James A. FitzPatrick  
Nuclear Power Plant  
268 Lake Road  
P.O. Box 41  
Lycoming, New York 13093  
315-342-3840

**SUBJECT: James A. FitzPatrick Nuclear Power Plant  
Docket No. 50-333**

**Response to Request for Additional Information regarding Proposed  
Alternative for the Repair of Control Rod Drive to Reactor Pressure Vessel  
Nozzle (RR-26)**

Figure I  
Sketch of CRD Cap Weld Crack (Not to Scale)

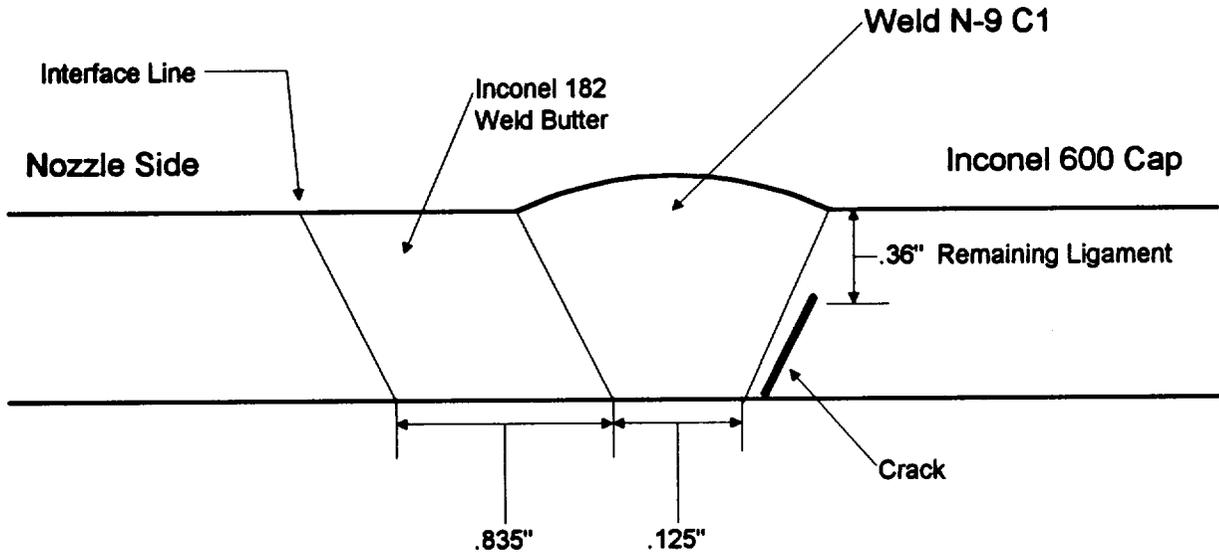
3. Provide a Sketch of the as found condition of the crack indication - See Figure 1.
